DESIGN 	DRAWN BY 	DART AEROSPACE LTD HAWKESBURY, ONTARIO, CANADA	
CHECKED 	APPROVED 	DRAWING NO. DSI 9224	REV. A SHEET 1 OF 1
DATE 01.11.21		TITLE CROSSTUBE SUPPORTS	SCALE NTS
A	01.11.21	NEW ISSUE

DART SERVICE INSTRUCTION

TO AMEND INSTALLATION INSTRUCTIONS

D205-594 Rev.D to Rev.G

INSTALL DART SUPPORTS AS FOLLOWS:

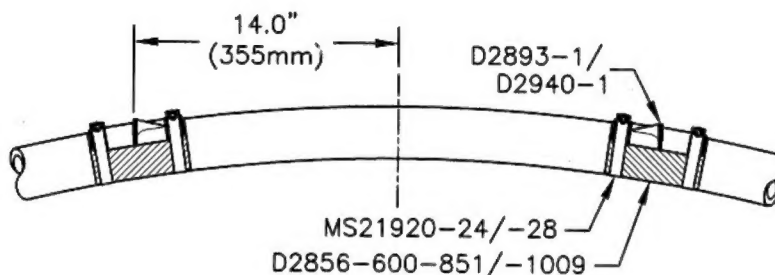
IT IS ACCEPTABLE TO SUBSTITUTE DART SUPPORTS FOR BHT SUPPORTS AS FOLLOWS:

DWG CALLS UP	REPLACE WITH
(2) 205-050-132-001 SUPPORT (2) 205-050-133-001 SUPPORT (4) 205-050-134-001 U-BOLT (8) MS21042L4 NUT (8) AN960JD416 WASHER	(2) D2893-1 SUPPORT (4) MS21920-24 CLAMP (2) D2856-600-851 ABRASION STRIP
(2) 205-050-132-003 SUPPORT (2) 205-050-133-003 SUPPORT (4) 205-050-134-003 U-BOLT (8) MS21042L4 NUT (8) AN960JD416 WASHER	(2) D2940-1 SUPPORT (4) MS21920-28 CLAMP (2) D2856-600-1009 ABRASION STRIP

CROSSTUBES WITH DART SUPPORTS SHOULD BE IDENTIFIED AS FOLLOWS:
